# City of Ukiah, CA Design Review Board

## MINUTES

6A. **(Revised) Gilbert Mixed Use Project, 676 South Orchard Avenue (File No.: 37)**  
Review and Recommendation to Planning Commission on a Site Development Permit for a mixed use development that would include the existing single-family home, modification and expansion of the existing garage which would be used for the commercial processing of wool, one food truck with outdoor seating, and modifications to the parking and landscaping at 676 South Orchard, APN 002-320-53. The Project also requires Planning Commission approval of a Major Use Permit to allow mixed residential and commercial use of the parcel.

# Incompleteness Letter 10/22/14

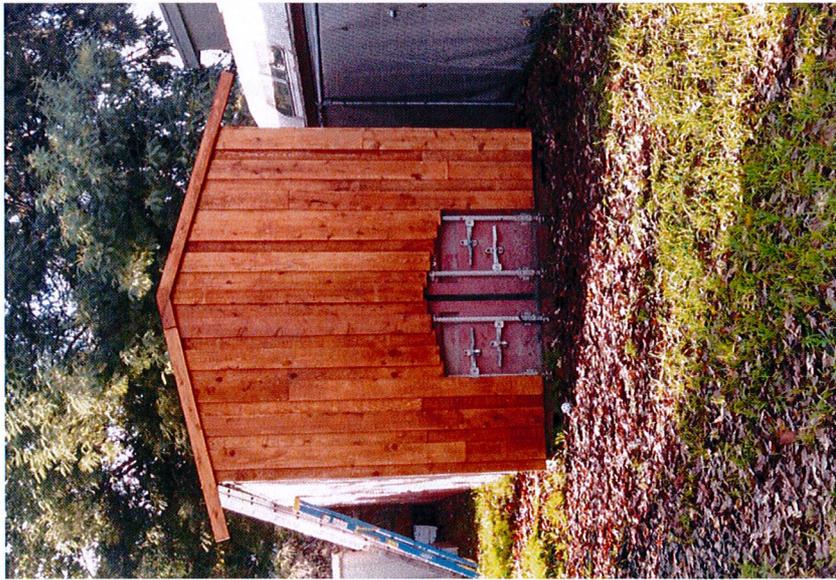
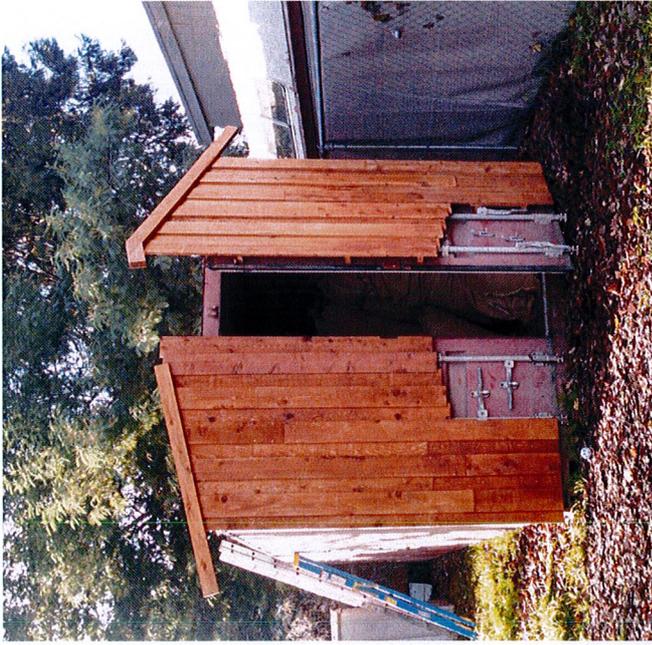
- “On the site plan...”
  - “Make the vehicle parking spaced more readable”
  - **Vehicle parking symbology has been changed.**
  - “The notes for the accessible and standard parking spaced appear to have been transposed.”
  - **The key notes have been corrected.**
  - “Note 9 states that 5 bike parking spaces are provided... .. 6 bike parking spaces (are needed).”
  - **Keynote 9 has been corrected to state that a minimum of 6 bicycle parking spaces will be provided.**
  - “Show the location of trash/recycling/waste disposal for all uses on the site.”
  - **Waste receptacle locations have been added.**
  - “Show the location of the required grease trap/interceptor.”
  - **The location of the grease trap has been added.**
